SUBJECT: Formally submits addl info re Cycle 9 operation Tech Spec  
 Table 3.5.1 adequately describes setpoint for full load.Clad  
 swelling & rupture,rod injection analysis & updated steam  
 generator tube rupture analysis addressed.

H. B. ROBINSON STEAM ELECTRIC PLANT, UNIT NO. 2  
DOCKET NO. 50-261  
LICENSE NO. DPR-23  
ADDITIONAL INFORMATION - CYCLE 9 OPERATION

Figure 6 Minimum DNB Ratio for Loss of Load

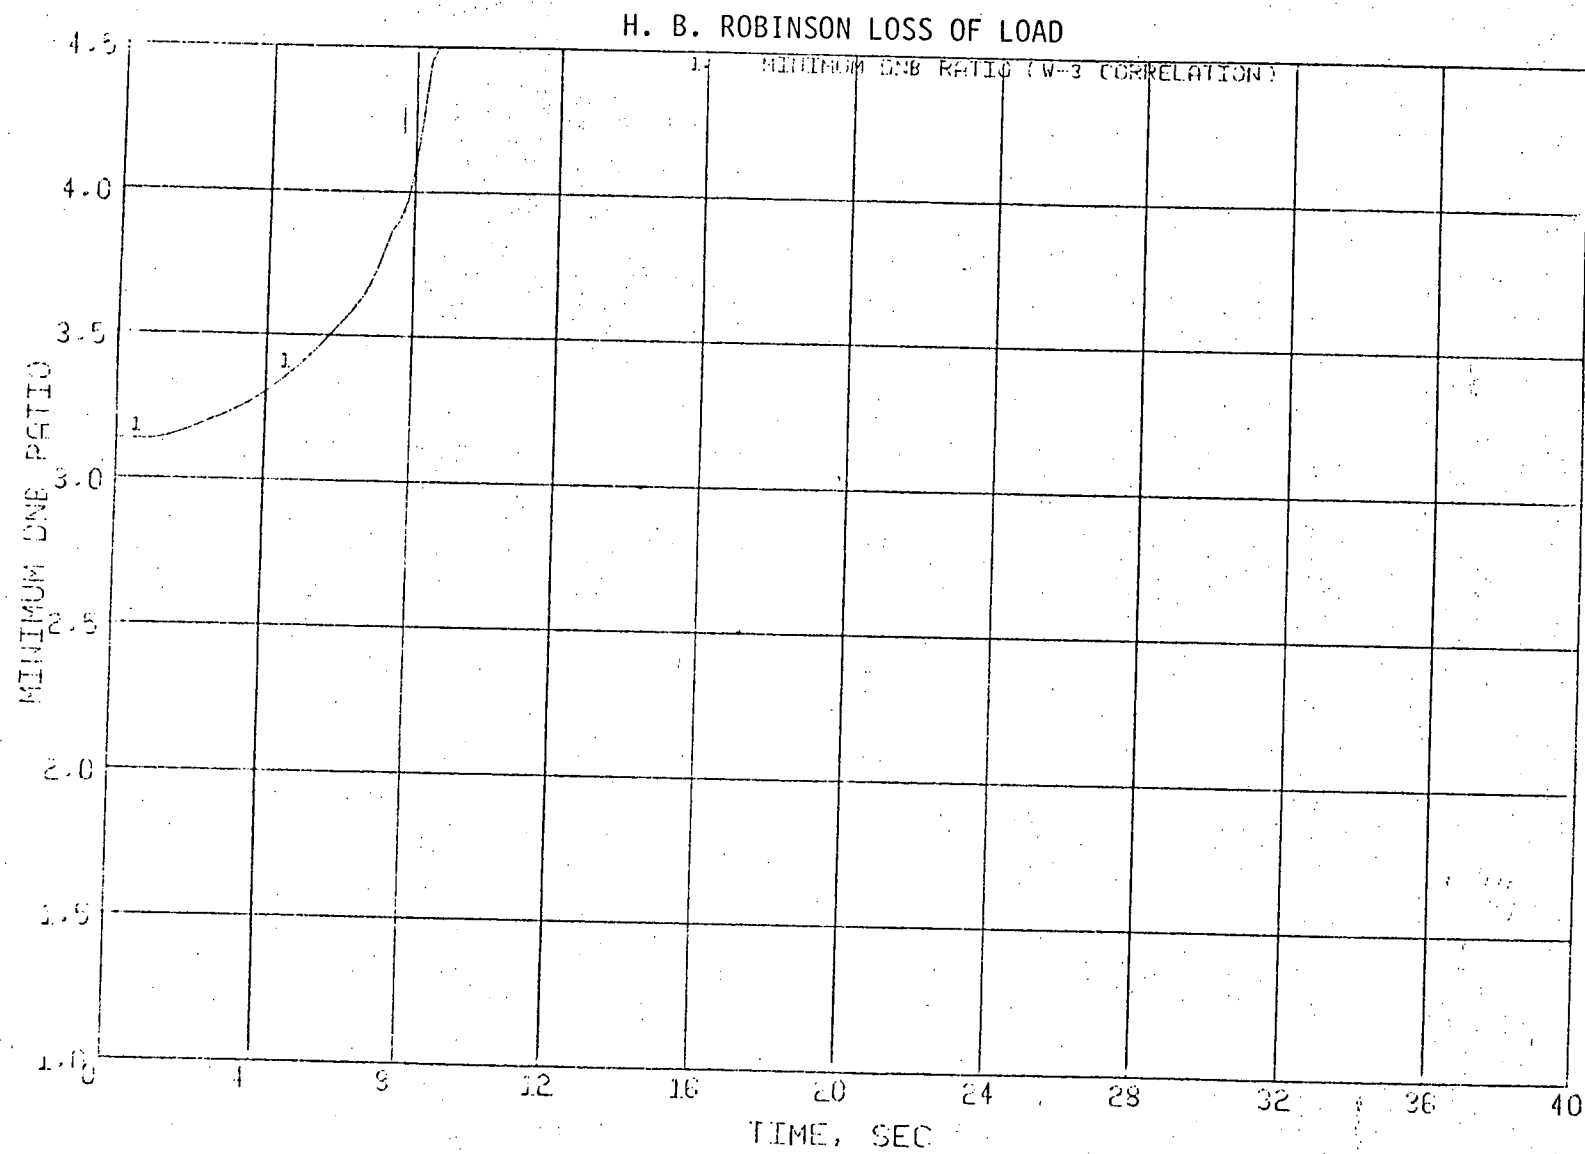
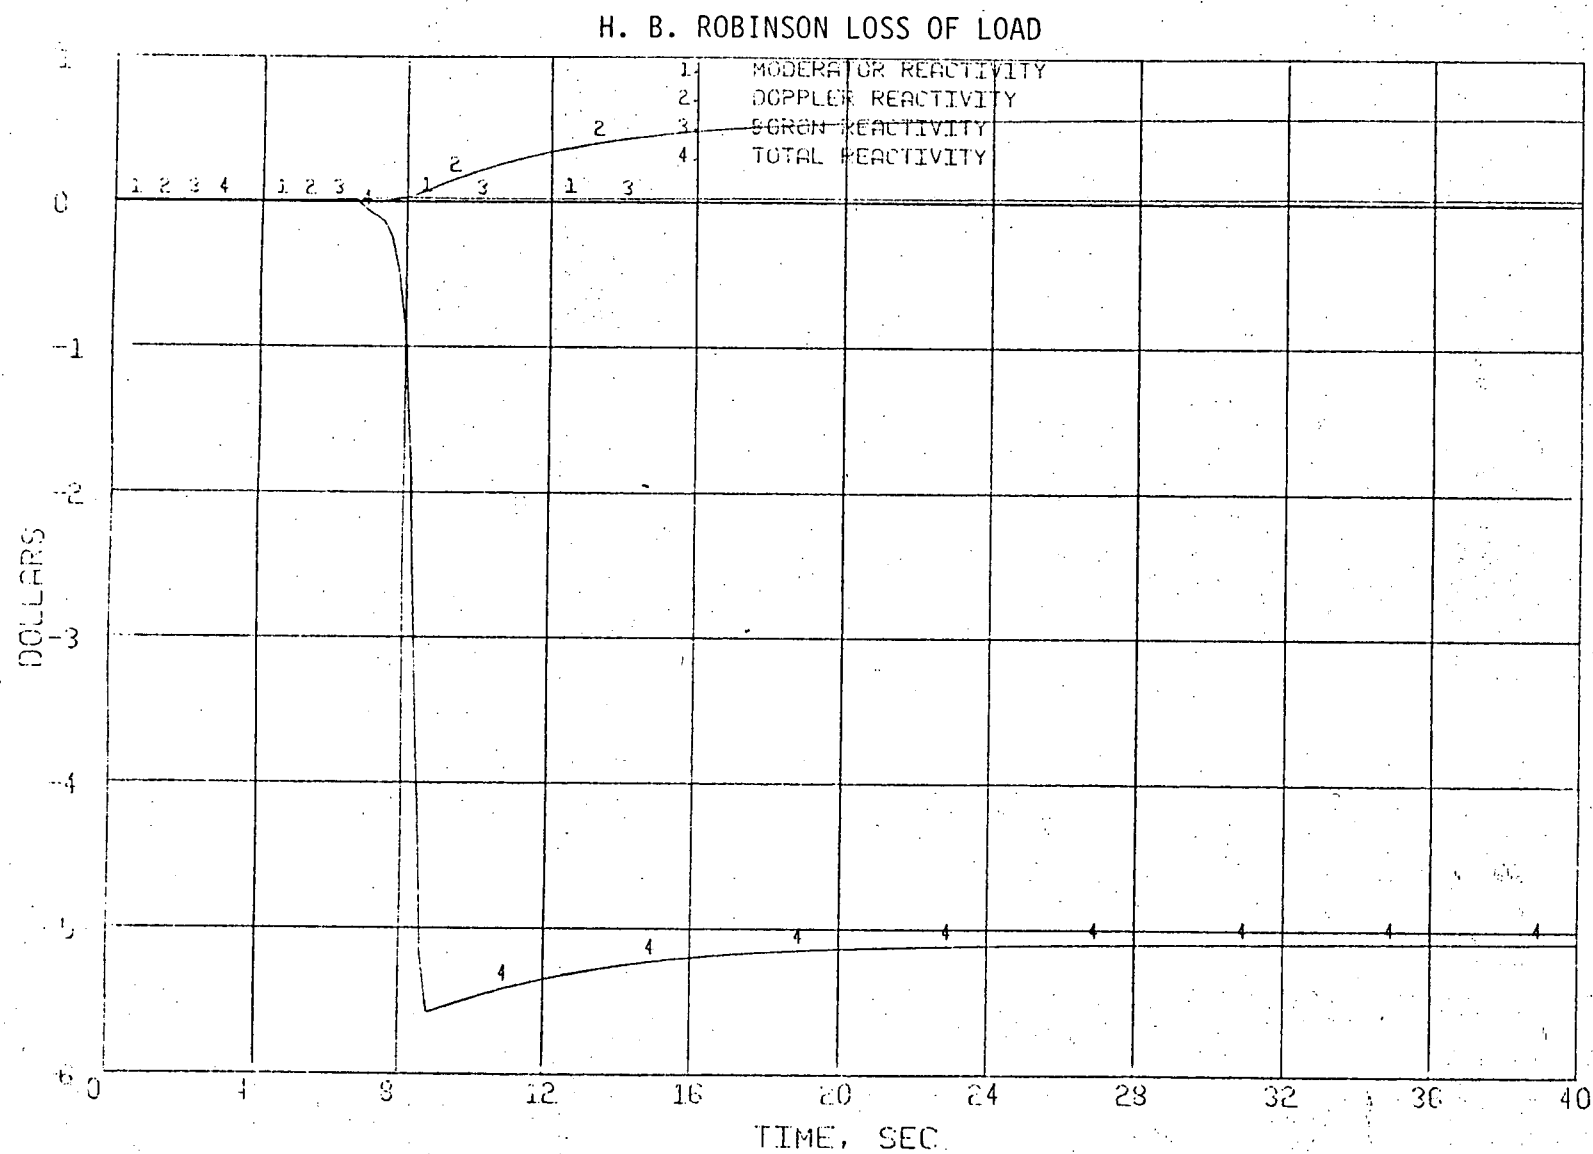
"The loss of load transient analyzed in ENC report XN-NF-82-18 results in a peak primary pressure of 2460 psia and a peak secondary pressure of 1051 psia. The set points for the primary safety valves is 2485 psig. The lowest steam generator safety valve setpoint is 1085 psig. Discuss whether your analysis provides sufficient allowance for uncertainties and setpoint tolerances and whether either the primary or secondary safety valves could lift under the most adverse combinations of uncertainties and set point tolerances and what the consequences of safety valve lifting would be."

"Loss of load involves plant behavior after a trip of the turbine-generator without a direct reactor trip. The present loss of load analysis has been made to evaluate peak primary system pressurization relative to the vessel integrity limit of 2750 psia. The transient responses for this event were evaluated from 1955 MWt with the most severe assumptions; namely, loss of load at BOC with a positive moderator coefficient (+2.5 pcm/°F) and no automatic reactor control. The steam dump and turbine bypass were not allowed. The feedwater pumps were assumed to trip with the reactor. The steam line power operated relief valves have been neglected. The steam line safety valves were assumed to operate. The pressurizer relief valve and pressurizer spray were assumed inoperable. Table 1 shows the safety valve setpoints and associated uncertainties used in the analysis. For conservatism, a multiplier of 0.8 was applied to the Doppler coefficient of -1.0 pcm/°F.

Figures 1 to 7 show the plant responses following a loss of load from 1955 MWt. After closure of the turbine stop valves, the pressure in both steam generators increases and reaches 1006 psia at 39.81 seconds. The steam line safety valve setpoint is not reached in 40 seconds. The reactor is tripped at 6.52 seconds on high pressure after 1.0 second delay. The pressurizer safety valve opens at 7.36 seconds. The peak primary pressure was 2585 psia, which is well below the maximum allowable value of 2750 psia. The average primary coolant temperature increases by less than 11°F. The minimum DNB ratio during the transient never gets below the initial value."
